Access Compliance Report

Public Rights-of-Way

Intersection ID: 48434	Main Street: ORANSAY_WY	Cross Street: WHITHORN_WY	Location: NW
ADA ID: F487EBEC117B	Ramp Type: Perp	Initial Pass/Fail: Fail	Overall Compliance: No
		Severity Score: 12.5

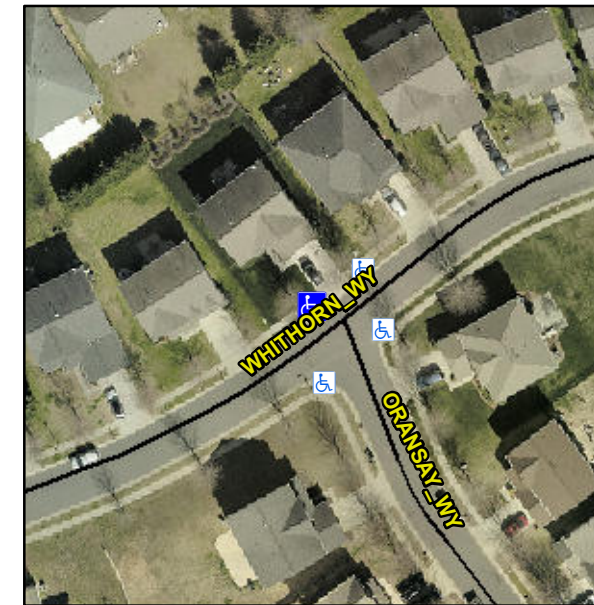
Not Found, R304.2.2

Compliance	Description	Data	Compliance	Description	Data
N/A	Ramp Length (in)	47.5	No	Ramp Slope (%)	9.0
Yes	Ramp Width (in)	48.0	Yes	Ramp XSlope (%)	1.2
N/A	Flare Type LT	N/A	N/A	Flare Type RT	N/A
N/A	Flare Slope LT (%)	N/A	N/A	Flare Slope RT (%)	N/A
N/A	Flare Traversable LT?	N/A	N/A	Flare Traversable RT?	N/A
N/A	Landing Length (in)	N/A	N/A	DWS Provided?	N/A
N/A	Landing Width (in)	N/A	N/A	DWS Contrast?	N/A
N/A	Landing Slope (%)	N/A	N/A	DWS Length (in)	N/A
N/A	Landing X Slope (%)	N/A	N/A	DWS Full Width?	N/A
N/A	Landing Curb? (Y/N)	N/A	N/A	DWS Offset (in)	N/A
N/A	Shared Landing?	N/A			
N/A	Gutter Ponding?	N/A	N/A	Gutter Slope (%)	N/A
N/A	Gutter Lip Ht (in)	N/A	N/A	Gutter X Slope (%)	N/A
N/A	Painted X Walk1?	No	N/A	Painted X Walk2?	N/A
	X Walk 1 Direction	To S		X Walk 2 Direction	N/A
N/A	X Walk 1 Width (in)	N/A	N/A	X Walk 2 Width (in)	N/A
	X Walk 1 Slope (%)	2.7		X Walk 2 Slope (%)	N/A
	X Walk 1 X Slope (%)	3.6		X Walk 2 X Slope (%)	N/A

Remove & Replace Entire Ramp.
